**Conditional Use Permit**  
**Staff Report and Recommendation**  
Community Development Department, Planning Division

**LAND USE REQUEST:** Conditional use permit for a recreational cannabis dispensary

**FILE NUMBER(S):** 311-20-000029-PLNG

**PROPERTY LOCATION:** 3139 Pacific Avenue

**Current Pacific Avenue façade (above) & rendering of the proposed façade (below)**

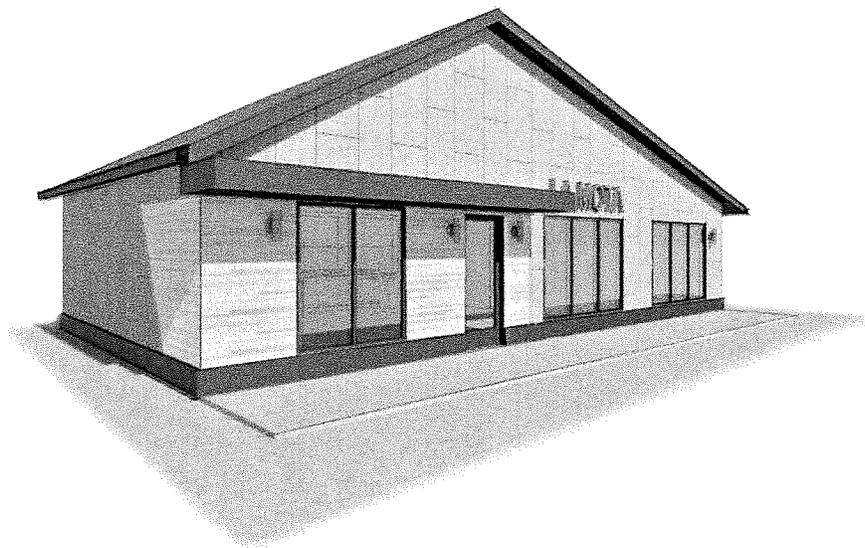
Finding: No changes to the site size, building scale, or setbacks are proposed. The building style would be modified with new storefront systems on the Pacific Avenue facade that would incorporate more of the Design Elements of DC §17.8.710(B)(3), including an awning.

Finding: The building's façade is not adjacent to the sidewalk, but it is adjacent to the pedestrian walkway connecting to the Pacific Avenue sidewalk and to the car park. As such, an awning over at least the building entrance is required, and has been incorporated into the design. This criterion is met.

Finding: The existing building already complies with these standards. The applicant proposes to install new storefront systems in the Pacific Avenue facade with window openings that at least equal the area of the existing windows. These standards are met.

SITE PLAN 4

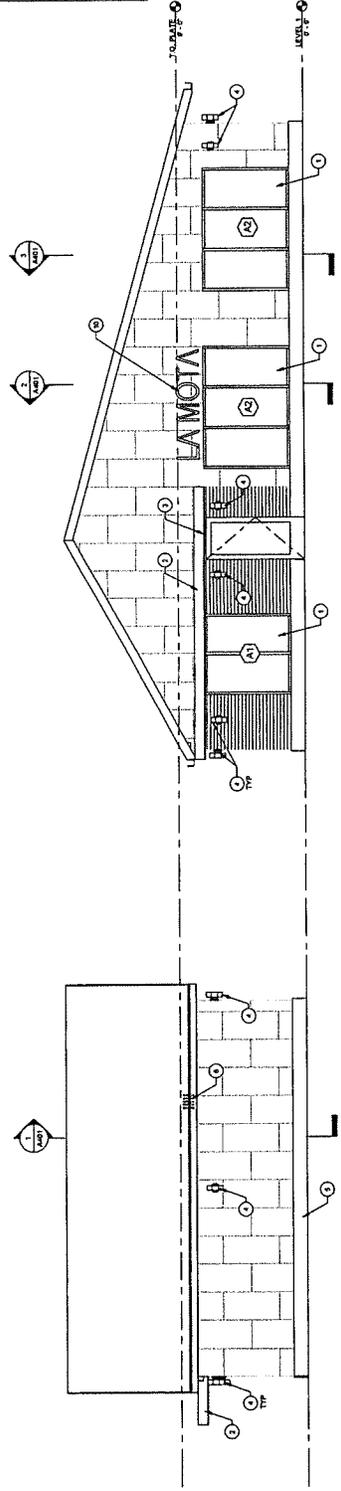
No new landscaping is proposed along the north edge of the car park since that area (aside from the residence) is a field. No landscaping is proposed along the west property line because it is so narrow, and cannot be expanded without encroaching into the driveway area. The Planning Commission could require a minimum 5-foot-wide landscape area along the west property line, but to do so would also require revising the traffic circulation plan by making a one-way loop around the building. Staff has included this as an optional **condition**.

Finding: No new landscaping is proposed along the north edge of the car park since that area (aside from the residence) is a field. No landscaping is proposed along the west property line because it is so narrow, and cannot be expanded without encroaching into the drive-way area. The Planning Commission could require a minimum 5-foot-wide landscape area along the west property line, but to do so would also require revising the traffic circulation plan by making a one-way loop around the building.

3. Install a minimum 5-foot-wide landscape area abutting the west property line, in compliance with DC §17.8.405 *Applicability*, DC §17.8.410 *General Provisions*, DC §17.8.420 *Landscaping Requirements by Zone*, and DC §17.8.545 et. seq. *Landscaping and Screening of Parking and Loading Areas*.
4. Concurrent with Condition #3, stripe the car park for one-way traffic circulation.
